Recall Bulletin

PRODUCT SAFETY RECALL

SUBJECT: Front Safety Belt Anchor

MODELS: 2009-2014 Buick Enclave
2009-2014 Chevrolet Traverse
2009-2014 GMC Acadia
2009-2010 Saturn Outlook

3910757

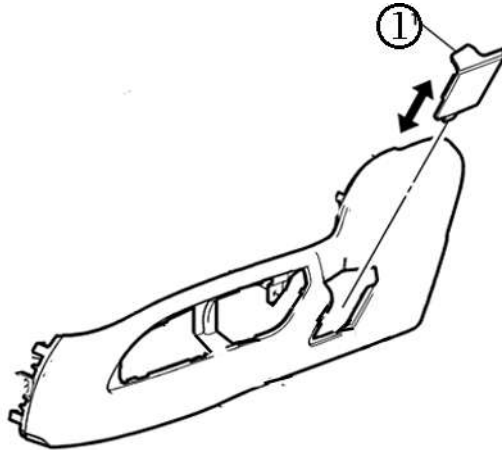
1. Move the front seat to the full forward and full downward position.

3916264

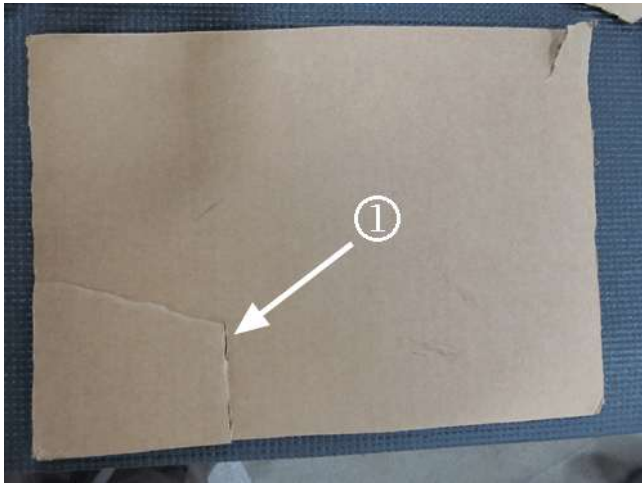
6. Using scissors, carefully cut and remove the rubber sleeve from the tensioner cable.
